Addendum 3 for RFB927940-04

Project Name: WRC Decentralization Phase 4 & Fire Alarm Phase 3 (9279.40 & 9279.41) Bid Issuance #4
DAS RFB #: 927940-04
DAS Project #: 9279.40 & 9279.41
Date: 6/2/2026

D3 BUILDING C AHU DUCT RISER & WALL PENETRATION PLAN
1/4" = 1'-0" 0' 6"

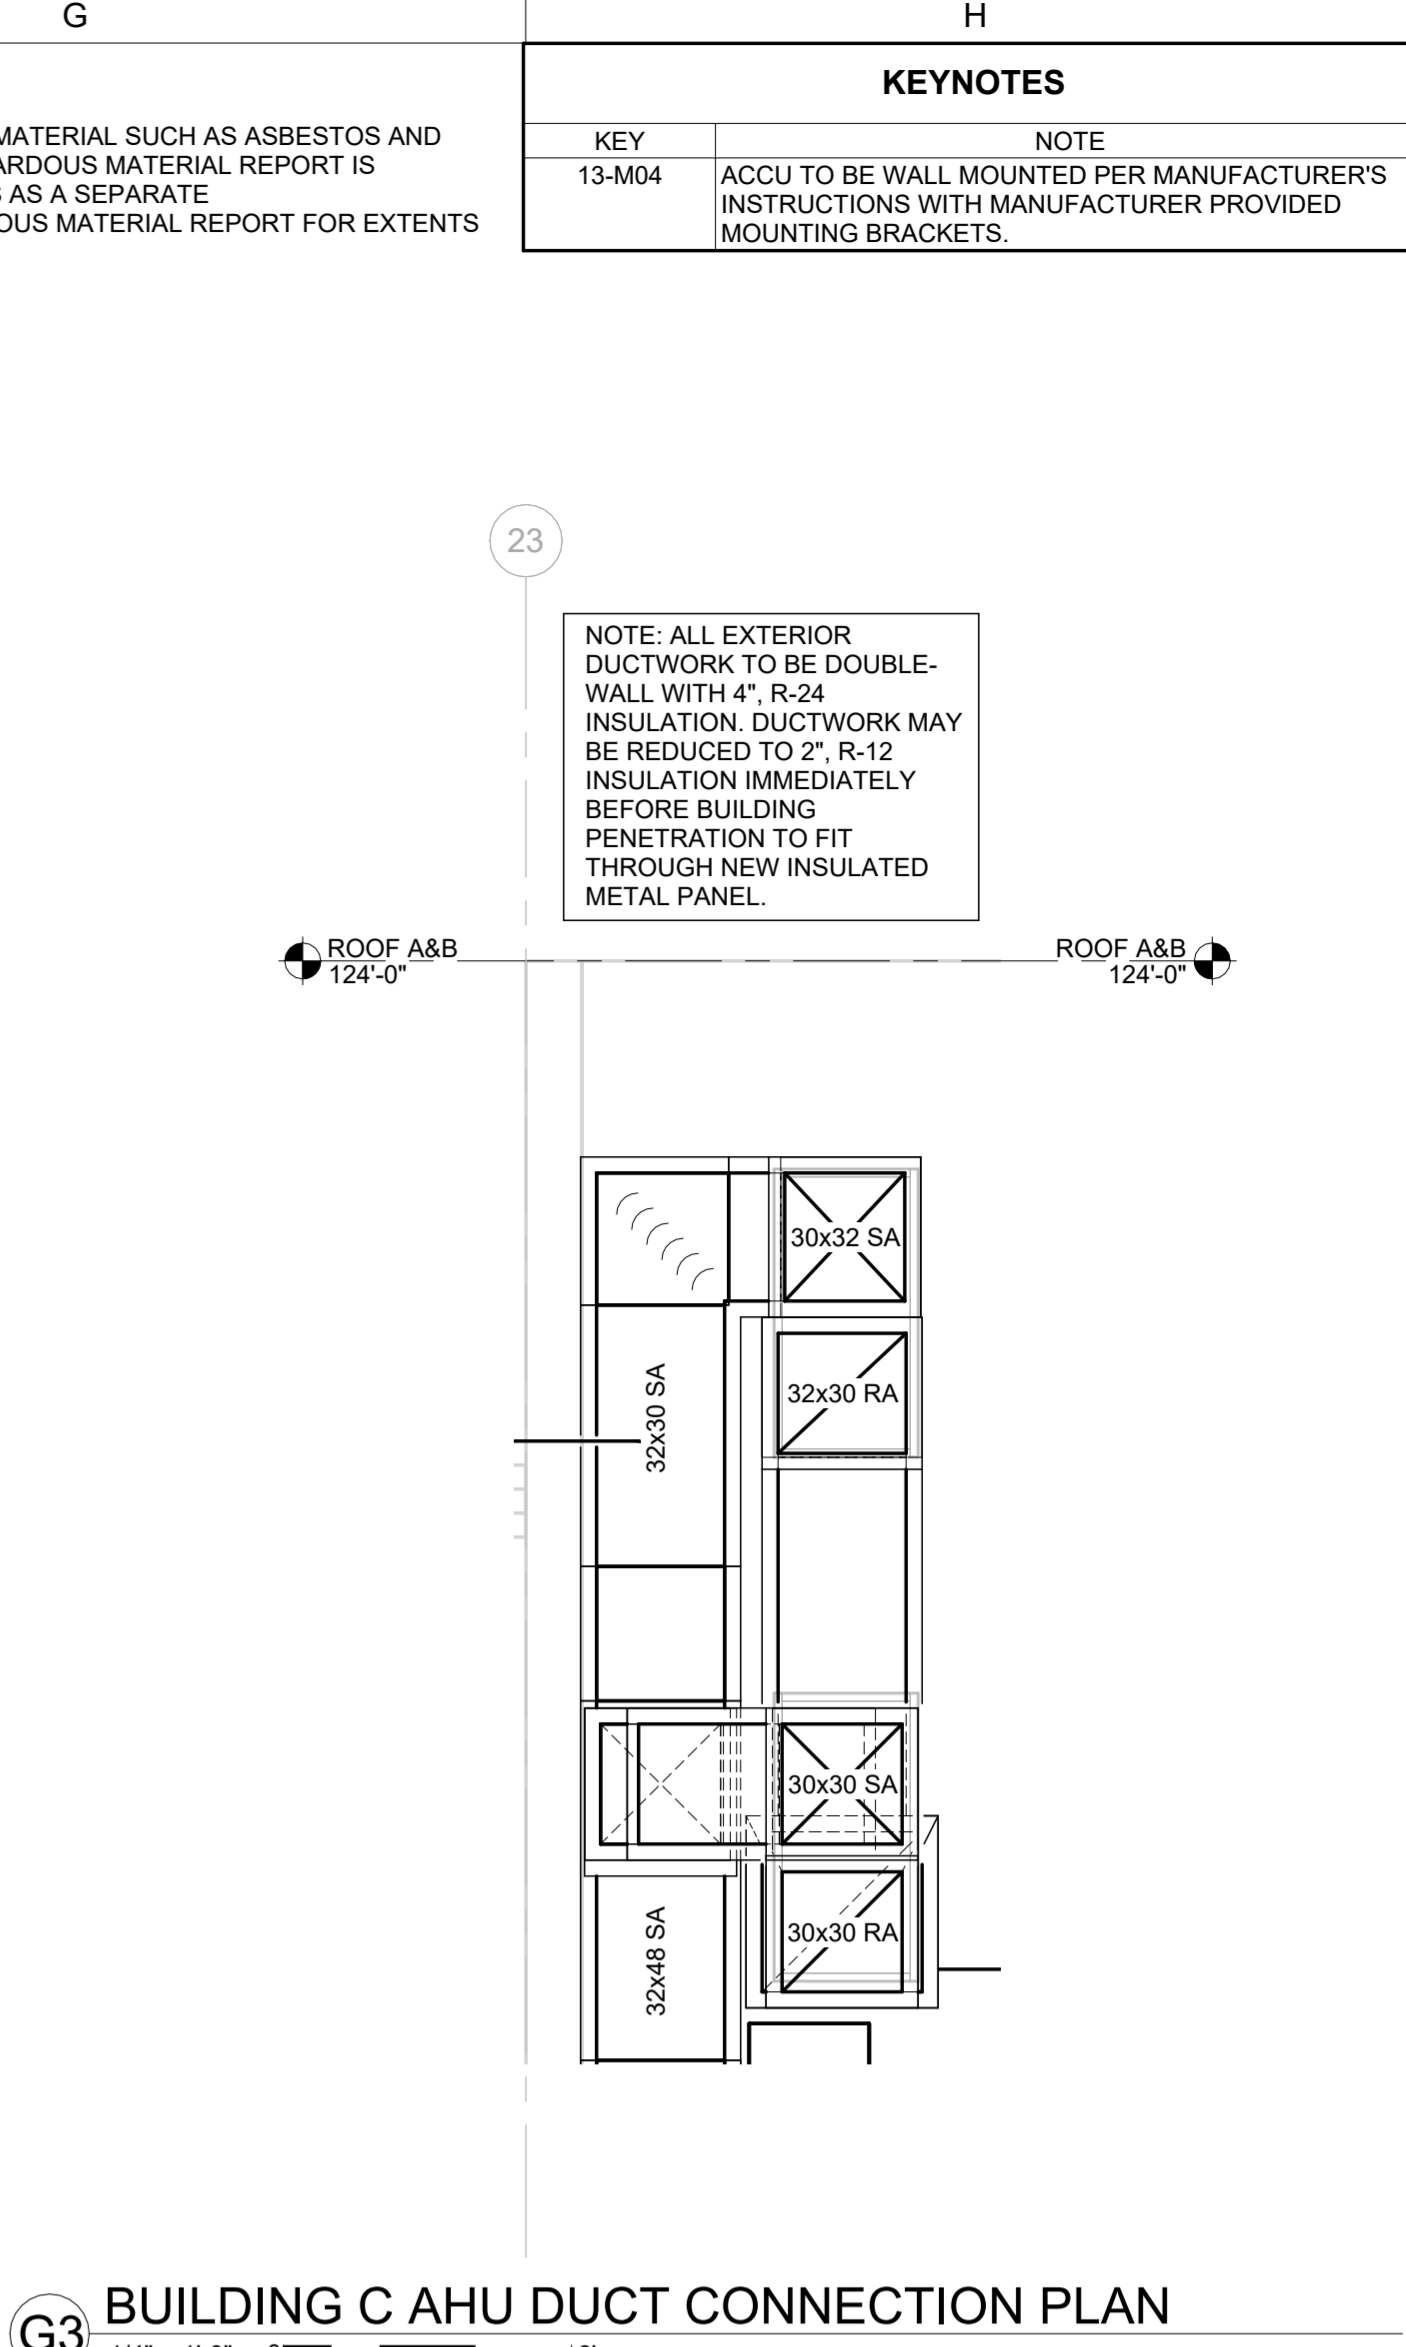
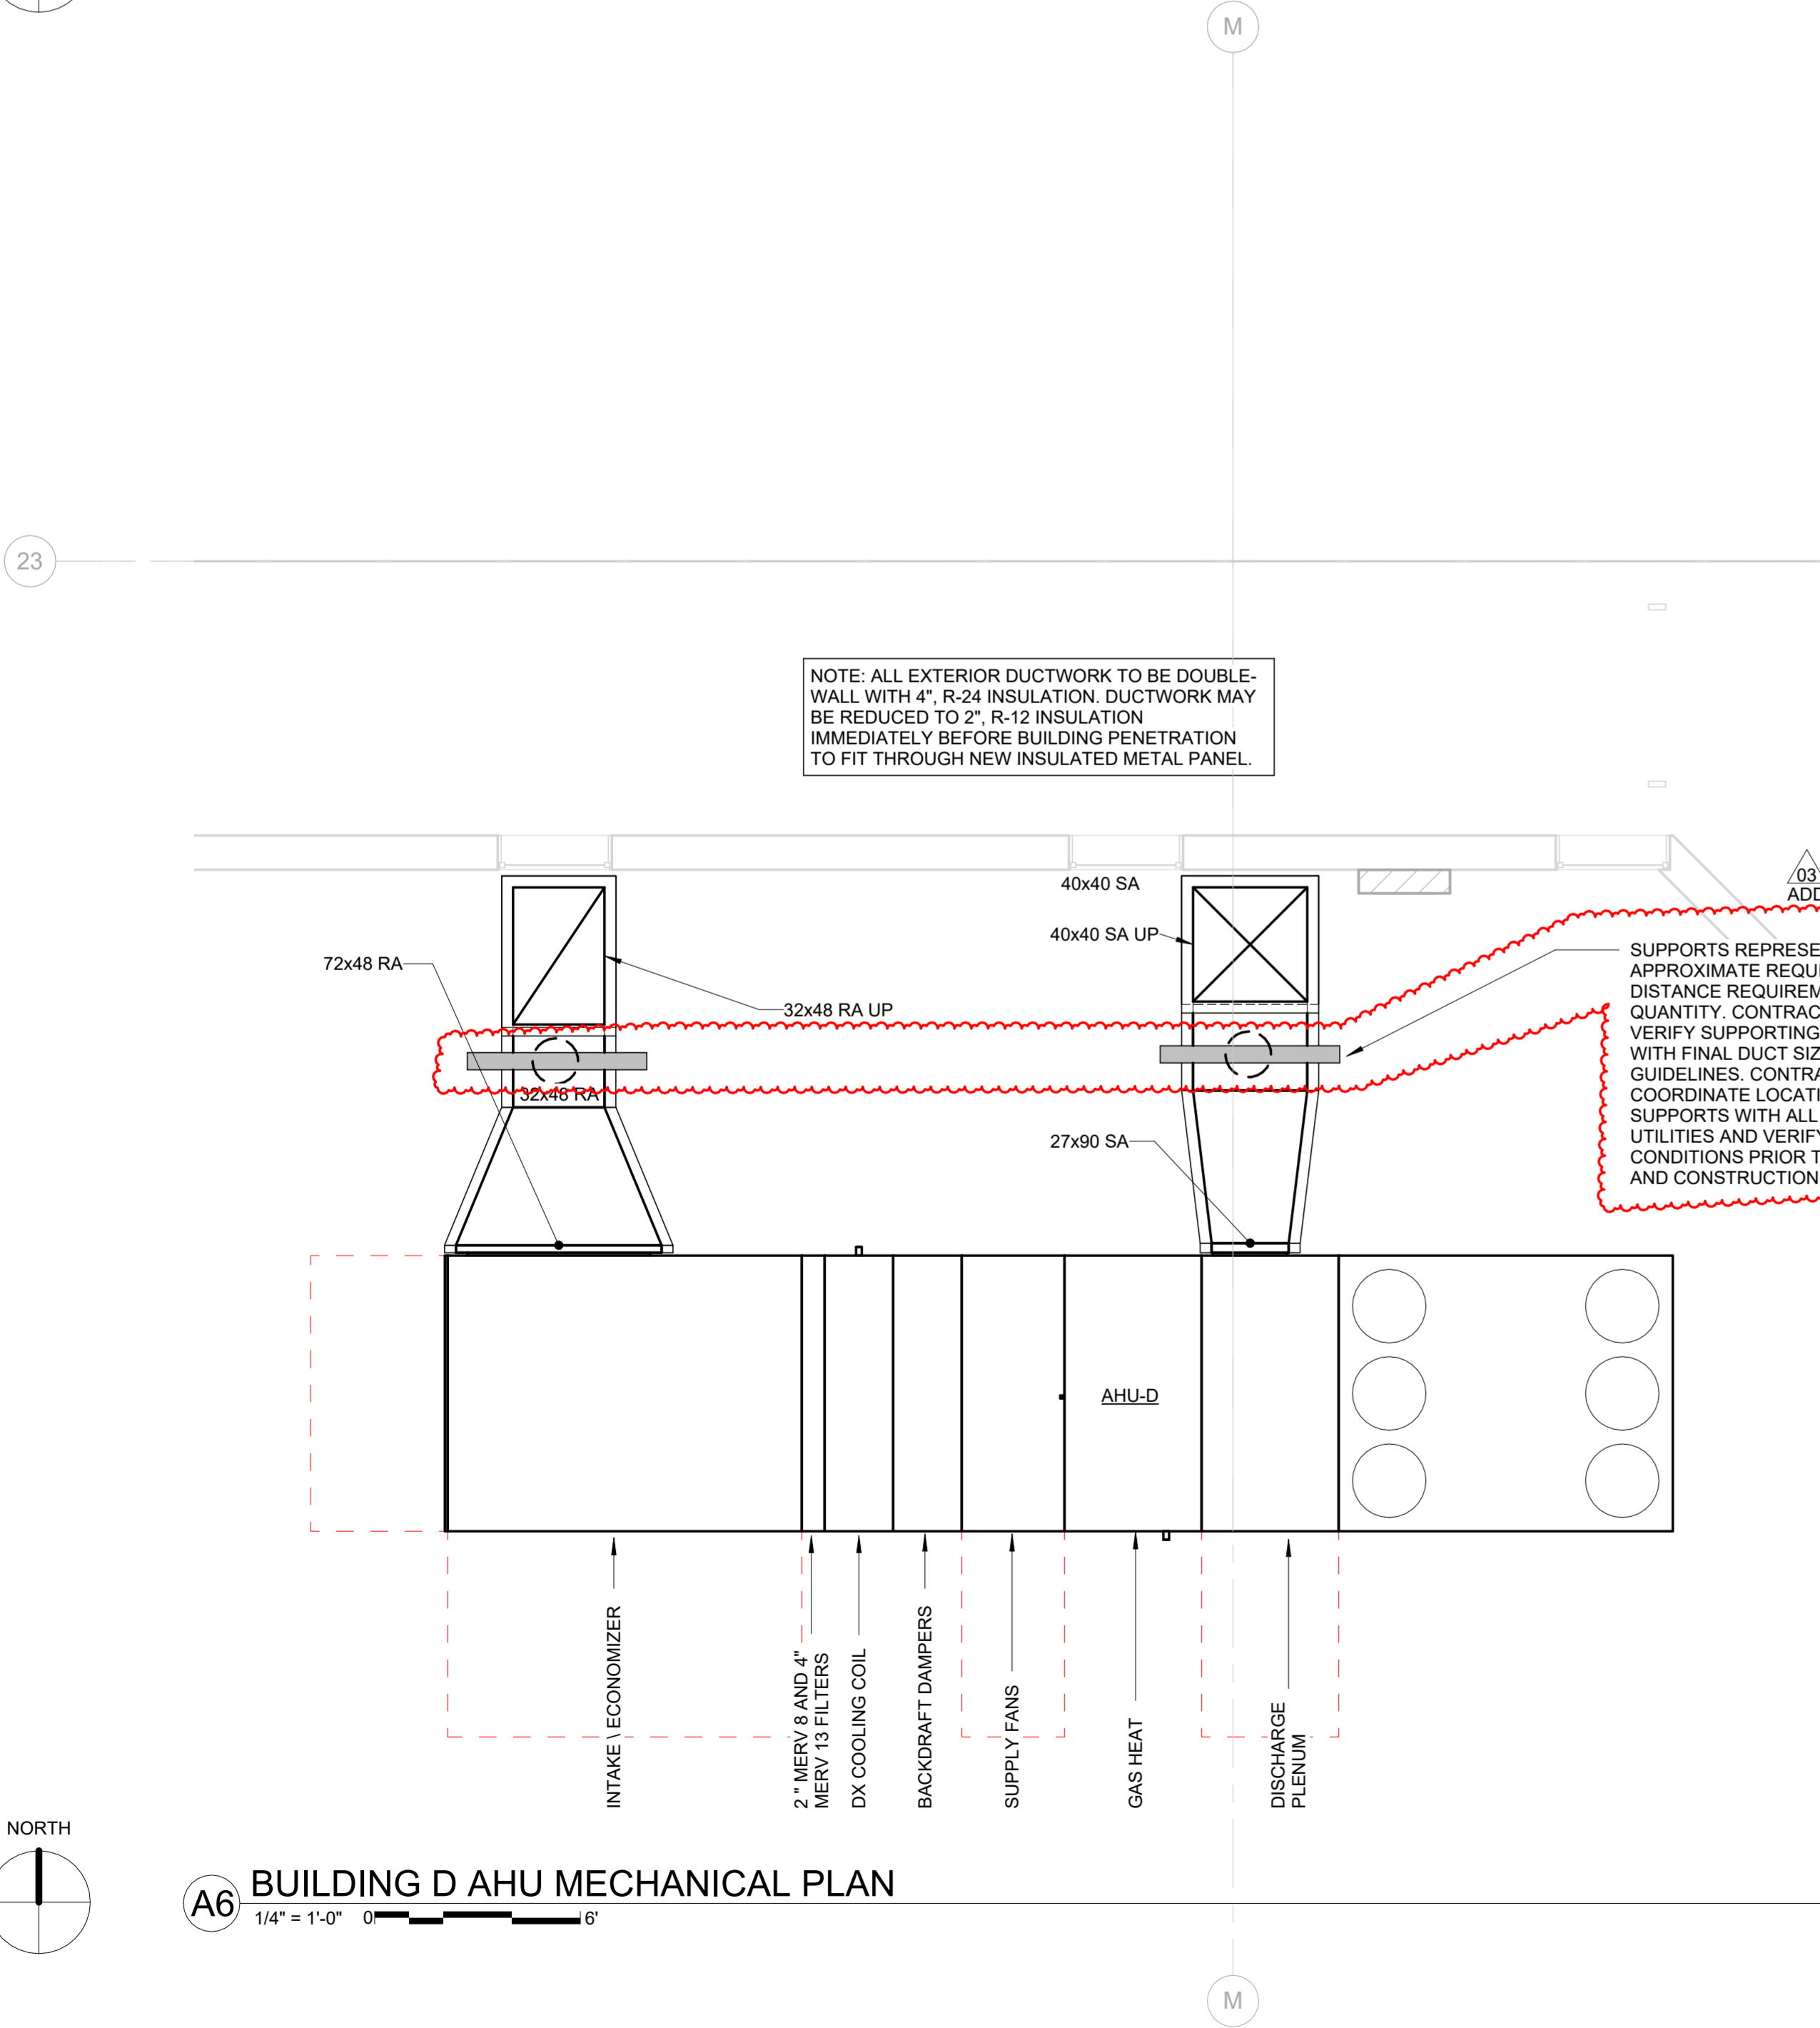
- **13-M300 – THERMOSTAT PLAN:**
 - **ADD** Tags to EUH-D-2 and ACCU-D-2.
- **13-M400 – BUILDING C & D ENLARGED AHU PLANS:**
 - **ADD** Approximate duct support locations to exterior ductwork and associated note “SUPPORTS REPRESENTATIVE OF APPROXIMATE REQUIRED SUPPORTING DISTANCE REQUIREMENTS AND QUANTITY. CONTRACTOR SHALL VERIFY SUPPORTING REQUIREMENTS WITH FINAL DUCT SIZES AND SMACNA GUIDELINES. CONTRACTOR SHALL COORDINATE LOCATIONS OF SUPPORTS WITH ALL UNDERGROUND UTILITIES AND VERIFY ALL EXISTING CONDITIONS PRIOR TO EXCAVATION AND CONSTRUCTION.”
